IRM Topology Update - Dover PAR Delay

ICS #281

October 4, 2023

Proposed 2024 – 2025 IRM FBC Topology for New York Control Area

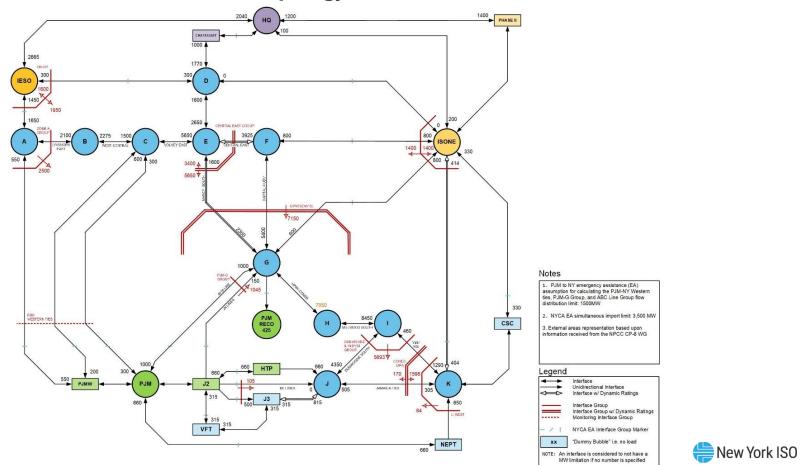
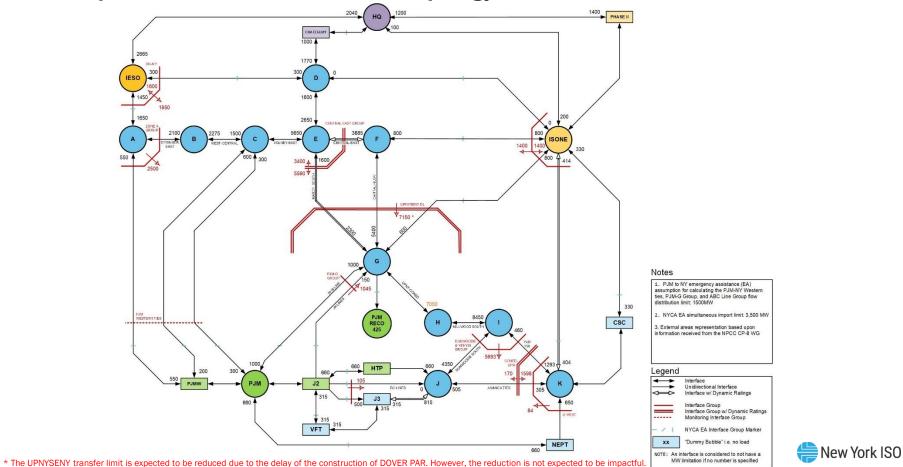
- The delay of the Dover PAR is expected to affect the Central East voltage limit due to the bypassing of the PAR and series compensation at Knickerbocker
- NYISO Operations has updated the Central East Voltage Limits and showed a small reduction from the current IRM assumptions (Updated Central East Voltage Limits)
- NYISO tested the updated Central East Voltage Limits on this year's PBC and confirmed no IRM impact due to the change
 - Proportional adjustments are also applied to the limit of Central East + Marcy group

Forward Limits (MW)	Central East	Central East + Marcy Group
2024 - 2025 IRM PBC	3925/3875/3815/ 3710/3595/3470	5650/5575/5490/ 5335/5160/4960
Proposed Change for 2024 – 2025 IRM FBC	3885/3805/3725/ 3640/3540/3460	5590/5475/5360/ 5235/5080/4945
Delta	-40/-70/-90/ -70/-55/-10	-60/-100/-130/ -100/-80/-15

- Reverting the improvement on UPNYSENY transfer limit represents 1900 MW reduction on the PBC assumption
- Given the lack of completed detailed study and the expectation of no impact on the IRM study, the NYISO propose to make no change to the UPNYSENY transfer limit in the 2024-2025 IRM FBC to account for the delay of Dover PAR

Transfer Limits	PBC Assumption Matrix	PBC Database	Proposed Change for FBC Assumption Matrix
I to J Forward Limits	4350	4400	4400
Neptune Reverse Limit	650	660	660
